Final Chelan River Use Attainability Analysis and Associated Water Quality Criteria

Technical Support Document

Water Quality Program

Publication 21-10-037

Figure 23 Comparison of simulated probabilities of two or more non-overlapping exceedances and one or more Exceedances for Reaches 1-3 (adapted from Mugunthan et al. 2019).

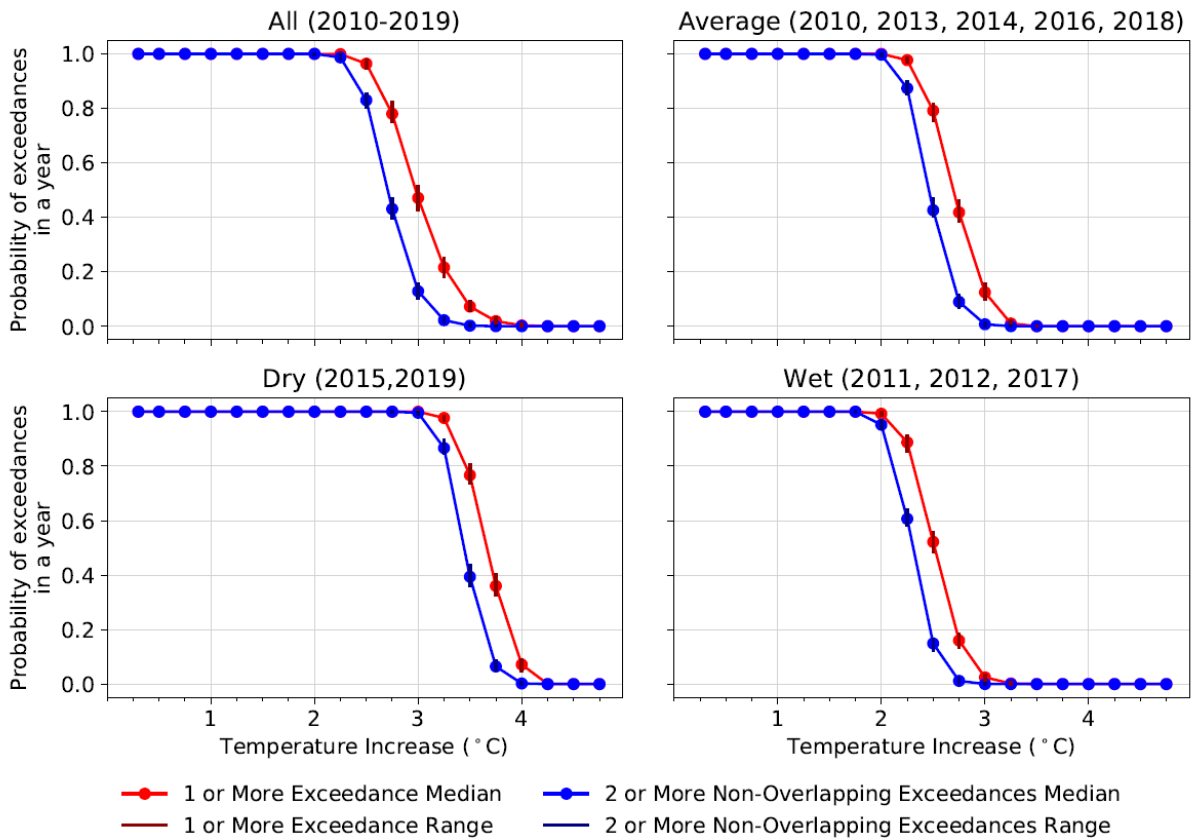
differential from the top of Reach 1 to the end of Reach 3. Chelan PUD proposed a temperature increase from the LLO to the end of Reach 3 of 3.6°C. The Chelan PUD proposed 7-DADMax temperature increase of 3.6°C coupled with a duration of two or more non-overlapping 7-DADMax increased is predicted never to occur in the future based on statistical analyses.

Chelan PUD proposed a maximum allowable increase in the 7-DADMax of 3.6°C for Reaches 1-3. Chelan PUD's proposal of an allowable temperature increase of 3.6°C coupled with defining an exceedance as two or more non-overlapping 7-DADMax temperature increases is predicted to never result in a future exceedance based on statistical analyses. This proposal is not adequately stringent when considering the frequency component to temperature criteria, monitoring data, and statistical analyses. Washington's statewide temperature criteria has an allowable exceedance frequency of no more than once every 10 years on average, that in turn, provides flexibility and allows for an occasional exceedance during extreme climatic years. Using the standard definition of an exceedance, statistical analyses conducted by Chelan PUD suggests that an allowable 7-DADMax temperature increase of 3.75°C would be exceeded once every 50 years and 3.5°C would be exceeded once every 14 years. While this may not exactly align with the temperature criteria frequency of no more than one exceedance every 10 years, monitoring data from 2010-2018 has demonstrated warming up to 3.5°C on dry years (Figure 9). We have decided to adopt a 7-DADMax temperature increase of 3.5°C to align with the available monitoring data for Chelan River. A 3.50°C 7-DADMax temperature increase represents a lower magnitude than the proposed value of 3.6°C by Chelan PUD. Overall, the adopted site-specific temperature criterion represents a more stringent magnitude and duration component, than Chelan PUD's request.

The adopted criteria differ from Chelan PUD's proposal for site-specific temperature criteria in Reaches 1-3. Rather than using a modified definition of an exceedance (two or more non-overlapping 7-DADMax increases), we used the standard definition of an exceedance, where one or more values greater than the 7-DADMax increase is considered out of compliance. The standard definition of an exceedance aligns with current methods for determining compliance for temperature in all state waters. The use of two or more non-overlapping exceedances, as proposed by Chelan PUD, provides significantly more leniency and is based upon our Policy 1-11 listing methodology for impaired waters. The implementation of the water quality standards differs from the methodology for determining an impaired water. We contend that it is not necessary to modify the definition of an exceedance as it may result in difficulties in interpretation and that modification to the magnitude of the criteria is more appropriate.

Figure 24 Comparison of simulated probabilities of two or more non-overlapping exceedances and one or more exceedance for the Reach 4 habitat channel (adapted from Mugunthan et al. 2019).

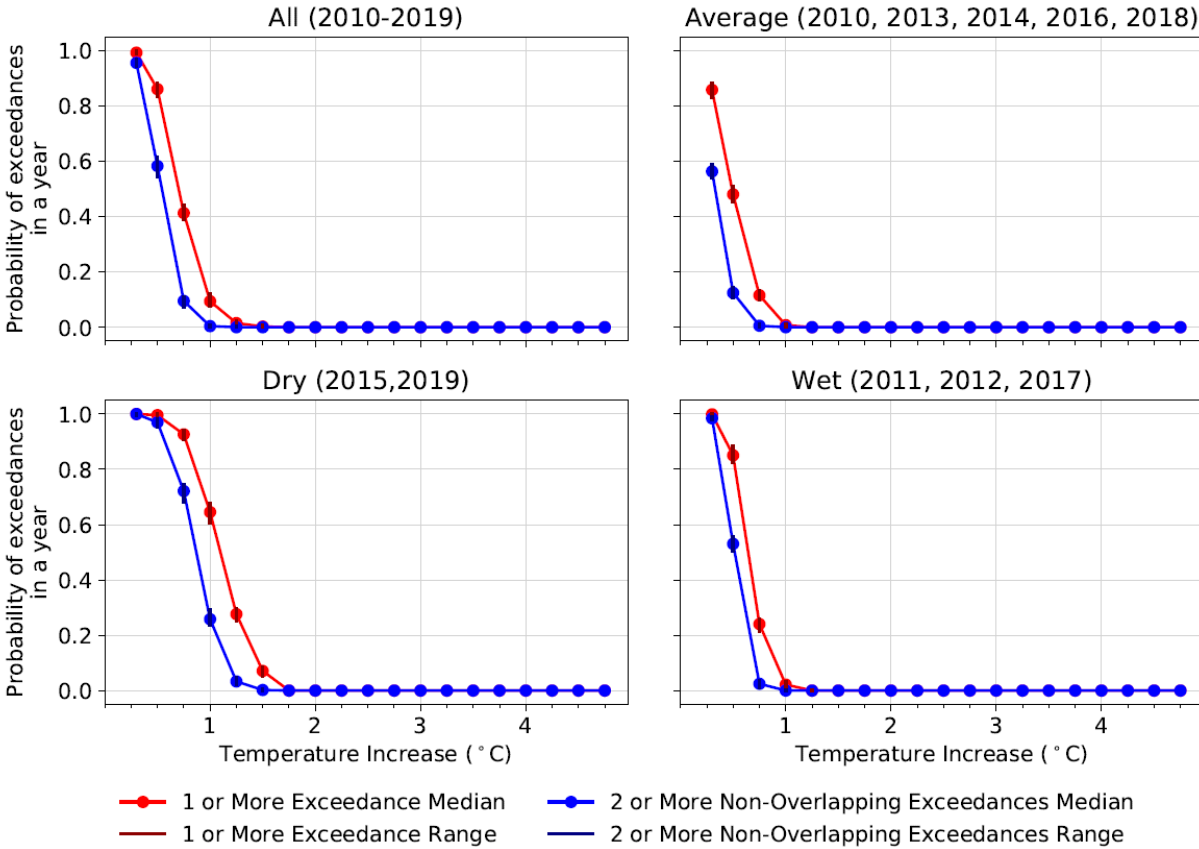
Chelan PUD has proposed a maximum increase in the 7-DADMax of 1.0°C for Reach 4. Chelan PUD's proposal of an allowable temperature increase of 1.0°C coupled with defining an exceedance as two or more non-overlapping 7-DADMax temperature increases is predicted to result in a water quality exceedance every 500 years based on statistical analyses. This proposal is not adequately stringent when considering the frequency component of temperature criteria, monitoring data, and statistical analyses. Washington's statewide temperature criteria have an allowable exceedance frequency of no more than once every 10 years on average that in turn, provides flexibility and allows for an occasional exceedance during extreme climatic years. Using the standard definition of an exceedance, statistical analyses conducted by Chelan PUD suggests that an allowable 7-DADMax temperature increase of 1.25°C would be exceeded approximately once every 56 years. While this may not align with the temperature criteria frequency of no more than one exceedance every 10 years, monitoring data from 2010-2018 has demonstrated warming up to 1.19°C on dry years (Figure 9). We have decided to adopt an allowable 7-DADMax temperature increase of 1.20°C to align with the available monitoring data for Chelan River. While the 1.20°C 7-DADMax temperature increase represents a higher magnitude than the proposed value of 1.0°C by Chelan PUD, the adopted SSC is more stringent because of the decision to use the standard definition of an exceedance.

The adopted criteria differ from Chelan PUD's proposal for site-specific temperature criteria in Reach 4. Rather than using a modified definition of an exceedance (two or more non-overlapping 7-DADMax increases), we used the standard method of an exceedance, where one or more values greater than the 7-DADMax increase is considered out of compliance. The standard definition of an exceedance aligns with current methods for determining compliance for temperature in all state waters. The use of two or more non-overlapping exceedances, as proposed by Chelan PUD, provides significantly more leniency and is based upon our Policy 1-11 listing methodology for impaired waters. The implementation of the water quality standards differs from the methodology for determining an impaired water. We contend that it is not necessary to modify the definition of an exceedance as it may result in difficulties in interpretation and that modification to the magnitude of the criteria is more appropriate.
